Access Compliance Report

Public Rights-of-Way

Intersection ID: 46672	Main Street: DAMASK_DR	Cross Street: HUNSLET_CR	Location:	N
ADA ID: 53A66A8192CA	Ramp Type: PerpDiag	Initial Pass/Fail: Fail	Overall Compliance: No	Severity Score: 10

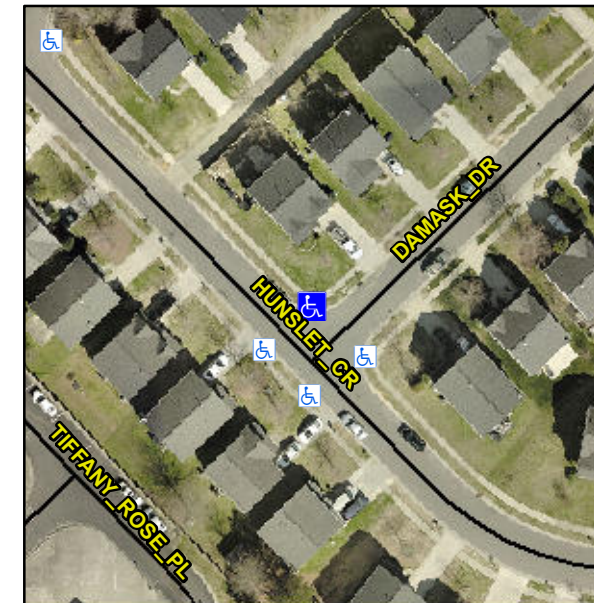
Not Found, R304.5.1, R304.5.3

Compliance	Description	Data	Compliance	Description	Data
N/A	Ramp Length (in)	48.0	Yes	Ramp Slope (%)	6.6
No	Ramp Width (in)	47.0	No	Ramp XSlope (%)	4.7
N/A	Flare Type LT	N/A	N/A	Flare Type RT	N/A
N/A	Flare Slope LT (%)	N/A	N/A	Flare Slope RT (%)	N/A
N/A	Flare Traversable LT?	N/A	N/A	Flare Traversable RT?	N/A
N/A	Landing Length (in)	N/A	N/A	DWS Provided?	N/A
N/A	Landing Width (in)	N/A	N/A	DWS Contrast?	N/A
N/A	Landing Slope (%)	N/A	N/A	DWS Length (in)	N/A
N/A	Landing X Slope (%)	N/A	N/A	DWS Full Width?	N/A
N/A	Landing Curb? (Y/N)	N/A	N/A	DWS Offset (in)	N/A
N/A	Shared Landing?	N/A			
N/A	Gutter Ponding?	N/A	N/A	Gutter Slope (%)	N/A
N/A	Gutter Lip Ht (in)	N/A	N/A	Gutter X Slope (%)	N/A
N/A	Painted X Walk1?	No	N/A	Painted X Walk2?	No
	X Walk 1 Direction	To SW		X Walk 2 Direction	To SE
N/A	X Walk 1 Width (in)	N/A	N/A	X Walk 2 Width (in)	N/A
	X Walk 1 Slope (%)	3.3		X Walk 2 Slope (%)	1.2
	X Walk 1 X Slope (%)	2.7		X Walk 2 X Slope (%)	1.0

Remove & Replace Curb Ramp With Two New Directional Ramps or Equivalent.
